Ratool Apparels Ltd.

Observations

Industrial shed-01

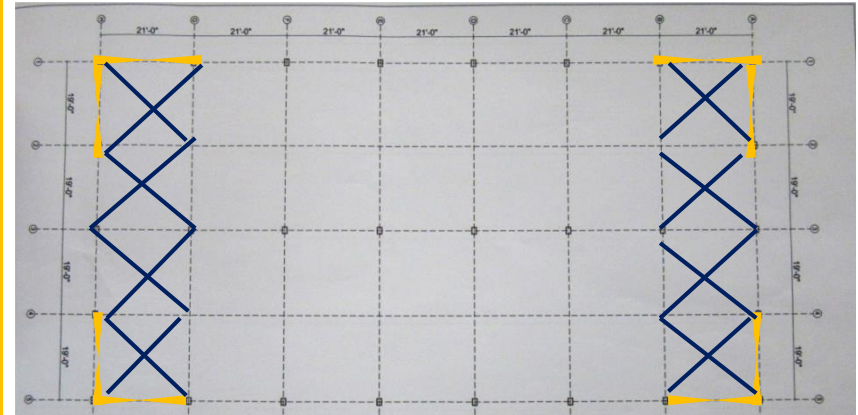
Neither vertical or horizontal bracing were observed in the design or at during the survey as constructed structure.

Industrial shed-03

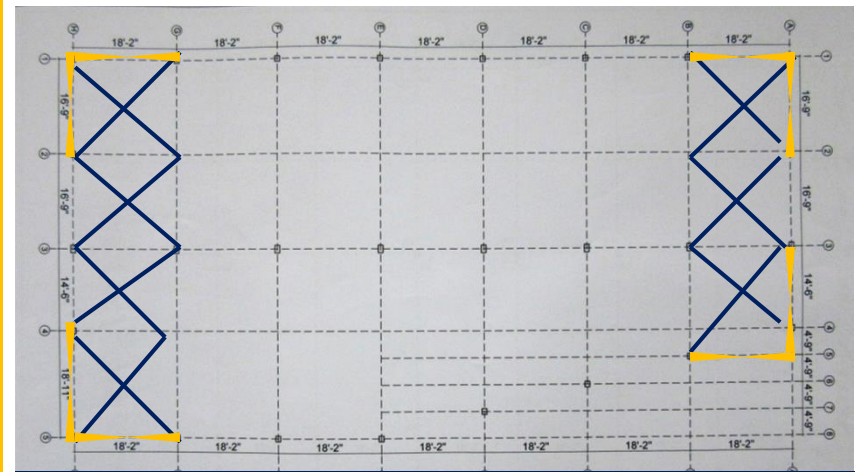
Non apparent lateral stability system. Possible vertical and horizontal bracing could look like the indicated drawings which were not observed on site.

Industrial shed-02

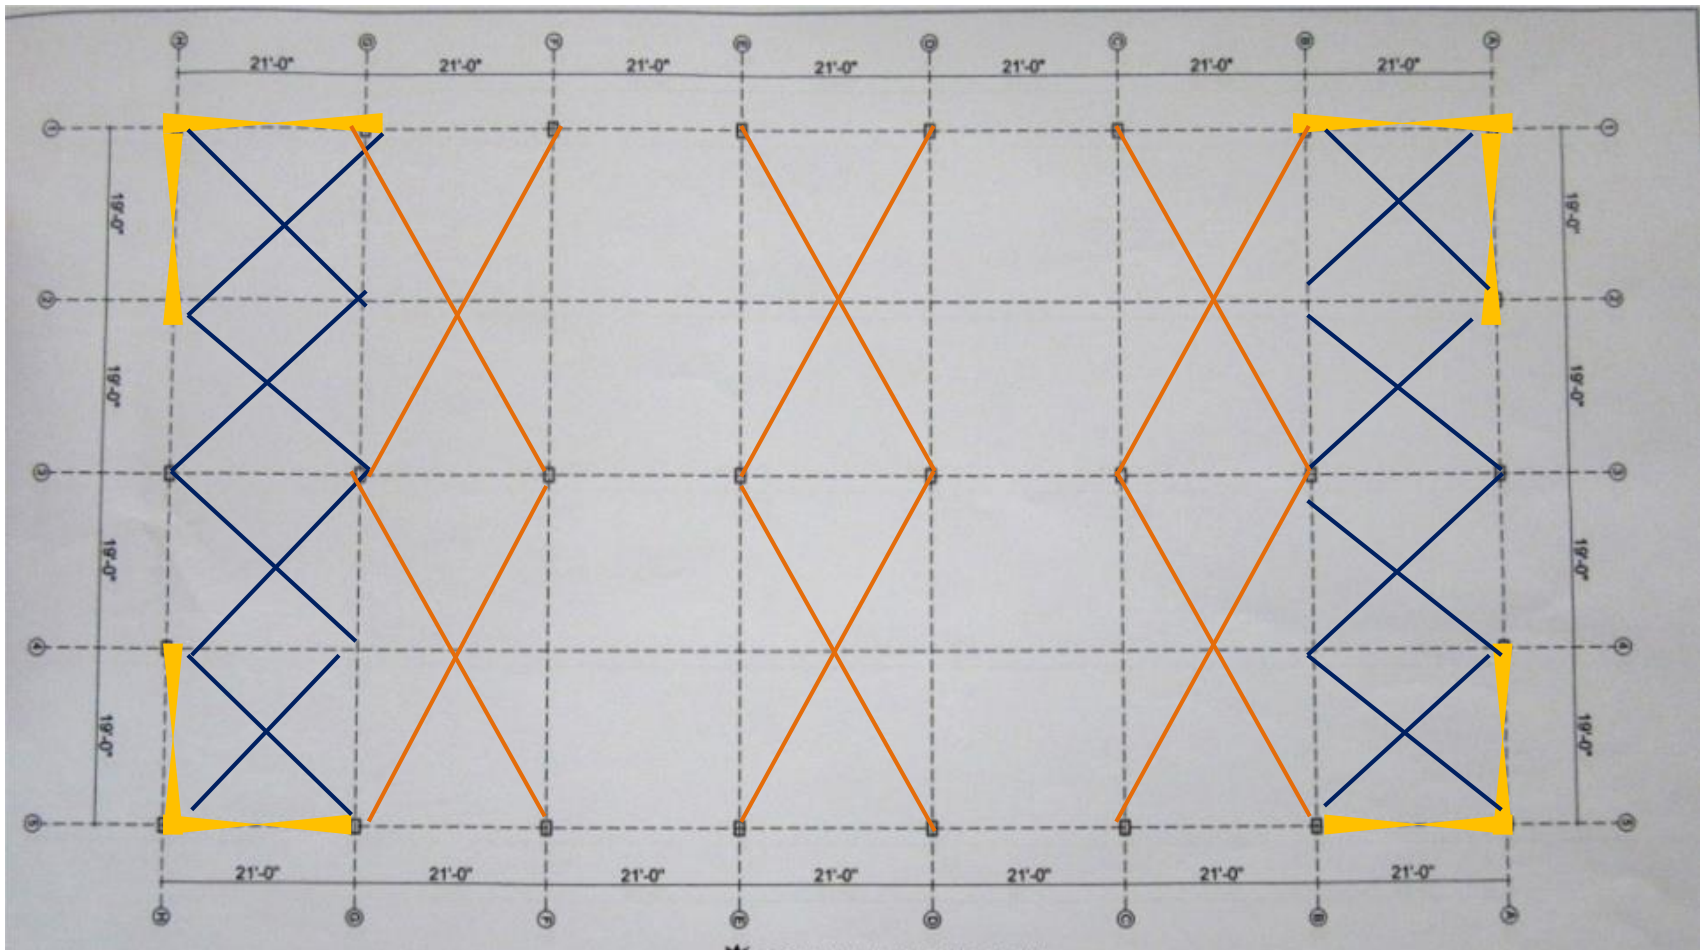
Observed bracing is not on the expected position.

Observed bracing

Apparent logical position of bracing
